MATERIAL		DRAWN BY	Jack.Seeley	04/02/2020
THICKNESS		CUSTOMER	NEBRA (PI SUPPLY)	
www.smartboxx.co.uk		PART NO.	4647 (GA) -02	
		REV 02	SCALE: 1:2	SHEET 1 OF 1
				A4

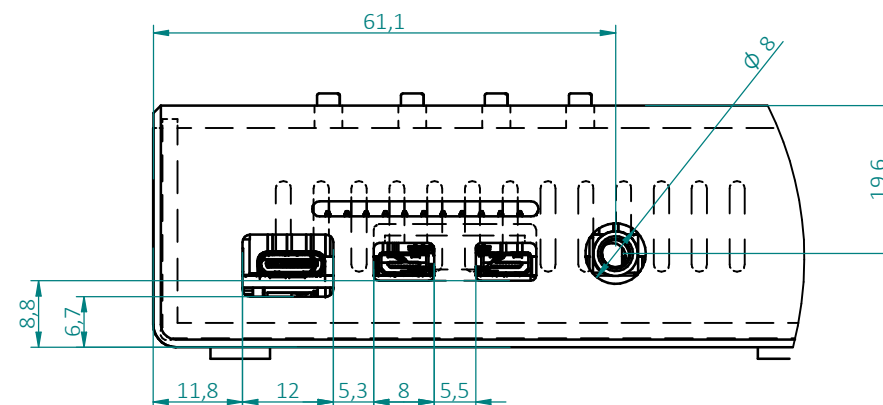
Pushout for Pi 3 HDMI port

DETAIL A

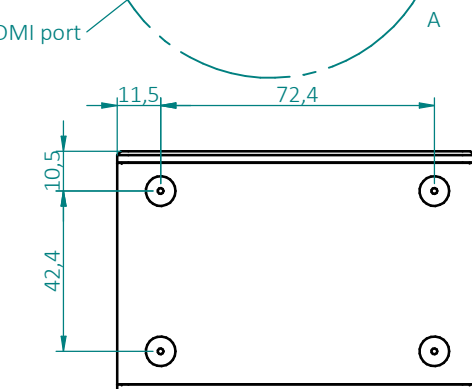
1.0 x 45° CHAMFER in the place of the 1.5mm Roundover to limit scratching.
